Access Compliance Report

Public Rights-of-Way

(Curb Ramps)

Intersection ID: 5837	Main Street: BLACK WALNUT LN	Cross Street: PEPPERBUSH CT	Location: W
ADA ID: 2881F027AF40	Ramp Type: Perp	Initial Pass/Fail: Fail	Overall Compliance: No
Severity Score: 10			
Codes/Mitigation Info/Possible Solution		Field Measurements/Component Compliance

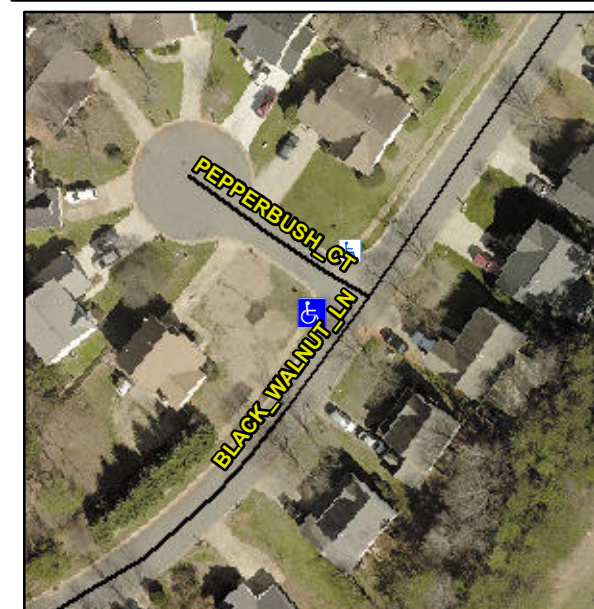
Not Found, R304.5.1, R304.5.3

Compliance	Description	Data	Compliance	Description	Data
N/A	Ramp Length (in)	98.0	Yes	Ramp Slope (%)	7.0
No	Ramp Width (in)	47.5	No	Ramp XSlope (%)	2.8
N/A	Flare Type LT	N/A	N/A	Flare Type RT	N/A
N/A	Flare Slope LT (%)	N/A	N/A	Flare Slope RT (%)	N/A
N/A	Flare Traversable LT?	N/A	N/A	Flare Traversable RT?	N/A
N/A	Landing Length (in)	N/A	N/A	DWS Provided?	N/A
N/A	Landing Width (in)	N/A	N/A	DWS Contrast?	N/A
N/A	Landing Slope (%)	N/A	N/A	DWS Length (in)	N/A
N/A	Landing X Slope (%)	N/A	N/A	DWS Full Width?	N/A
N/A	Landing Curb? (Y/N)	N/A	N/A	DWS Offset (in)	N/A
N/A	Shared Landing?	N/A			
N/A	Gutter Ponding?	N/A	N/A	Gutter Slope (%)	N/A
N/A	Gutter Lip Ht (in)	0.5	N/A	Gutter X Slope (%)	N/A
N/A	Painted X Walk1?	No	N/A	Painted X Walk2?	N/A
	X Walk 1 Direction	To NE		X Walk 2 Direction	N/A
N/A	X Walk 1 Width (in)	N/A	N/A	X Walk 2 Width (in)	N/A
	X Walk 1 Slope (%)	5.1		X Walk 2 Slope (%)	N/A
	X Walk 1 X Slope (%)	1.1		X Walk 2 X Slope (%)	N/A

Remove & Replace Entire Ramp.
